U.S. Department
Of Transportation
**Federal Highway
Administration**

March 19, 1996

Refer to: HNG-14/SS-53A

Supplement to Geometric and Roadside Design Acceptance Letter No. SS-53A

Figure 2. Manufacturer's Drawing of Test Article

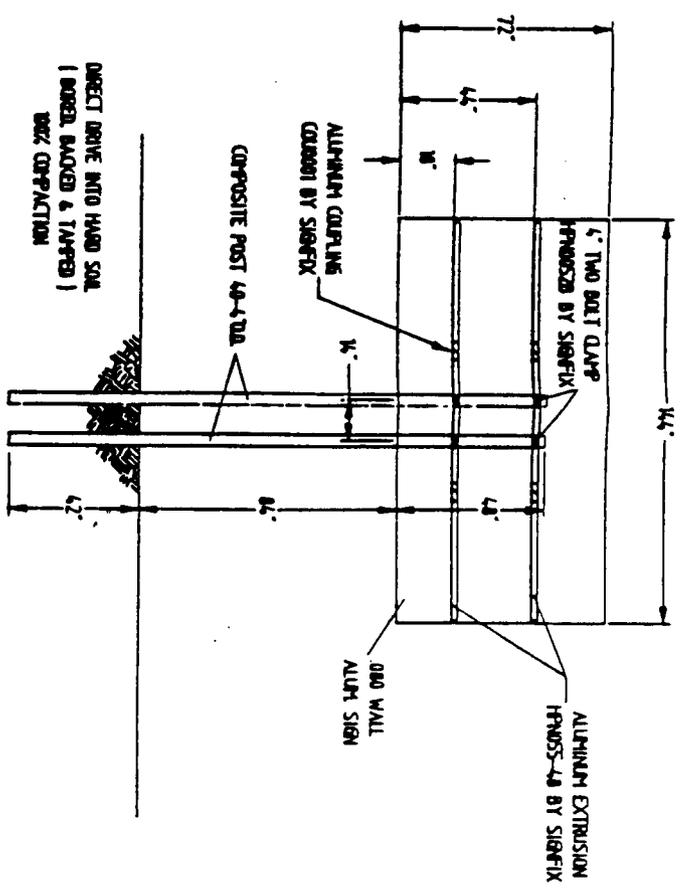
The two supports were spaced at 356-mm on center to facilitate testing with the pendulum. Pendulum testing is usually not permitted for qualifying base-bending/yielding small sign supports. In this case, however, previous high and low speed vehicle testing of single-post supports in standard soil (using drive sleeves) and in weak soil (using sleeves in a concrete foundation) revealed support breakaway mechanisms and vehicle responses that suggested the acceptability of using pendulum tests for evaluating design variations using the basic support posts. Based on the previous testing, the low occupant impact speed in the test under review here, and the breakaway characteristics of the posts, we conclude that the pendulum test report you submitted is sufficient to evaluate the acceptability of the dual-post support directly embedded in soil.

The results of this test met the change-in-velocity and stub-height requirements adopted by the FHWA. Your company's dual-post 102-mm diameter lightweight concrete-filled, fiber-reinforced plastic sign supports are therefore acceptable for use in standard soil on projects on the National Highway System (NHS) where breakaway systems are required if proposed by a State. Because this dual posttest without drive sleeves was successful, we will also consider single post installations in standard soil to be acceptable without drive sleeves. Dual-post installations in weak soil are not acceptable unless demonstrated through further crash testing.

Our acceptance is limited to the breakaway characteristics of the sign supports and does not cover the structural features. Presumably, you will supply potential users with sufficient information on design and installation requirements to ensure proper performance. We anticipate that the States will require certification from Lancaster Composite that the posts furnished has essentially the same chemistry, mechanical properties, and geometry as that used in the crash testing, and that they will meet the FHWA change in velocity requirements.
